Access Compliance Report

Public Rights-of-Way

(Curb Ramps)

Intersection ID: N/A	Main Street: SOUTHGROVE_ST	Cross Street: WAVERLY_WALK_AV	Location: SW
ADA ID: 1161E9297073	Ramp Type: Perp	Initial Pass/Fail: Fail	Overall Compliance: No
		Severity Score: 10

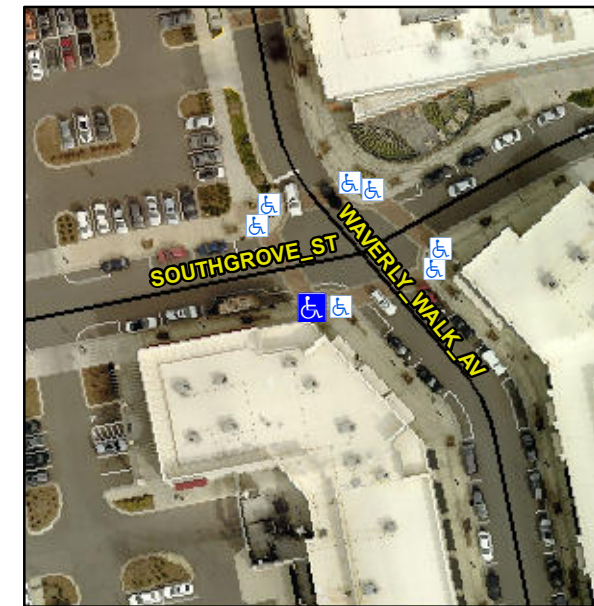
Not Found, R304.5.1, R304.5.3

Compliance	Description	Data	Compliance	Description	Data
N/A	Ramp Length (in)	65.0	Yes	Ramp Slope (%)	6.9
No	Ramp Width (in)	47.5	No	Ramp XSlope (%)	2.6
N/A	Flare Type LT	N/A	N/A	Flare Type RT	N/A
N/A	Flare Slope LT (%)	N/A	N/A	Flare Slope RT (%)	N/A
N/A	Flare Traversable LT?	N/A	N/A	Flare Traversable RT?	N/A
N/A	Landing Length (in)	N/A	N/A	DWS Provided?	N/A
N/A	Landing Width (in)	N/A	N/A	DWS Contrast?	N/A
N/A	Landing Slope (%)	N/A	N/A	DWS Length (in)	N/A
N/A	Landing X Slope (%)	N/A	N/A	DWS Full Width?	N/A
N/A	Landing Curb? (Y/N)	N/A	N/A	DWS Offset (in)	N/A
N/A	Shared Landing?	N/A			
N/A	Gutter Ponding?	N/A	N/A	Gutter Slope (%)	N/A
N/A	Gutter Lip Ht (in)	1.5	N/A	Gutter X Slope (%)	N/A
N/A	Painted X Walk1?	Yes	N/A	Painted X Walk2?	N/A
	X Walk 1 Direction	To N		X Walk 2 Direction	N/A
N/A	X Walk 1 Width (in)	104.0	N/A	X Walk 2 Width (in)	N/A
	X Walk 1 Slope (%)	0.8		X Walk 2 Slope (%)	N/A
	X Walk 1 X Slope (%)	1.5		X Walk 2 X Slope (%)	N/A

Remove & Replace Entire Ramp.
